INDESIT company

Model type:
WITL125EU

Commercial code:
F034281

1140960 Exploded views

n1040345: Replacement of drum lock button TL EVOII.

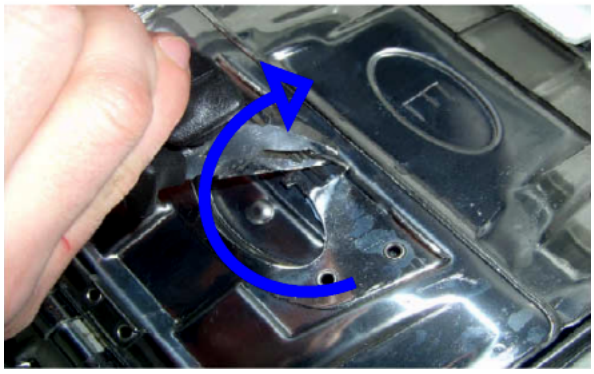
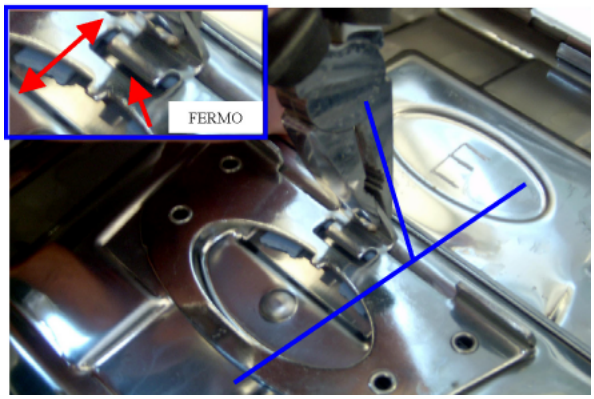
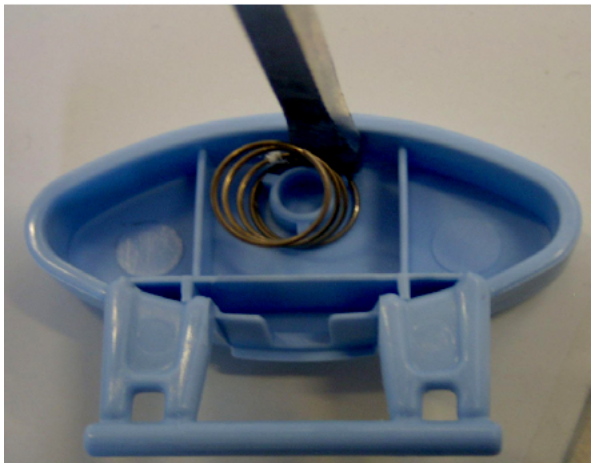
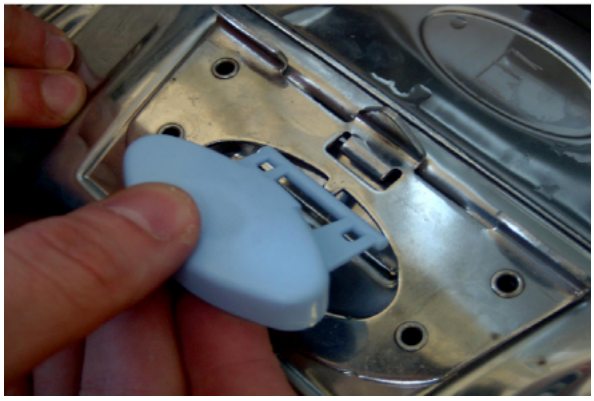
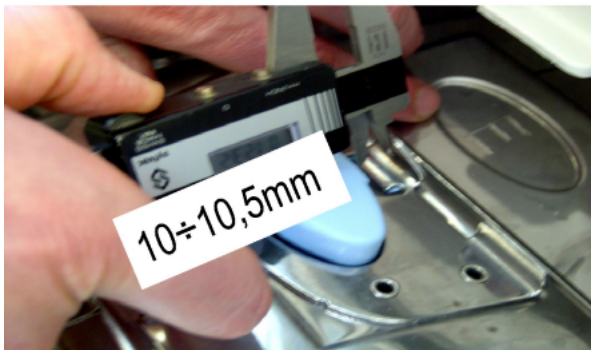
1) turn the central tip of the catch in the direction shown (FIG.1);

2) bring the tip to a vertical position and ensure that the broken button is disengaged from the catch restraint and can be removed (FIG.2);

3) remove the remaining part of the button with the aid of a screwdriver, taking care not to scratch the doors (FIG.3);

4) pre-assemble spring to button (FIG.4);

5) insert button between catch and door (FIG.5);

6) bring the button into position and arrange the spring in its location in the door (FIG.6);

7) turn the central tip of the catch in the direction shown to return it to its starting position (FIG.7);

8) check the distance between button and catch (FIG.8);

9) check correct operation of the button when opening and closing the doors (slight inclination errors of the catch can result in faulty closing of the doors) (FIG.9).

n1040382: Drain pump with bayonet-style filter - top Loading Brembate

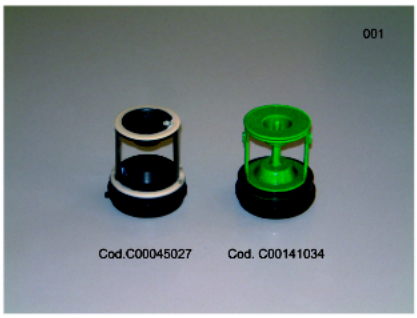
From serial no. 51021.0001 a new drain pump with bayonet-style filter has been installed on all top loading washing machines manufactured in Brembate.

New parts:
C00141862 - Drain pump
C00141034 - Pump filter kit

Premodification parts:
C00111409 - Drain pump
C00045027 - Pump filter kit

The new parts can be used instead of premodification ones.

N1040404FIG1

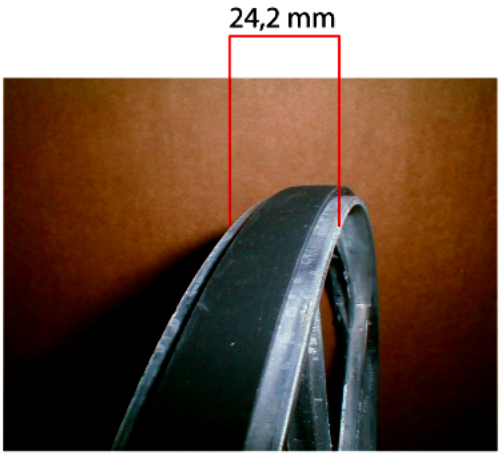
From serial no. 70122.0001 the pulley track has been widened from 21.2mm to 24.2mm (see picture N1040404FIG1).

new pulley
C00142832 - D280 24.2 mm track

Premodification pulley
C00083912 - D280 21.2 mm track

The new pulley can also be used on premodification versions of the models referred to in this release.
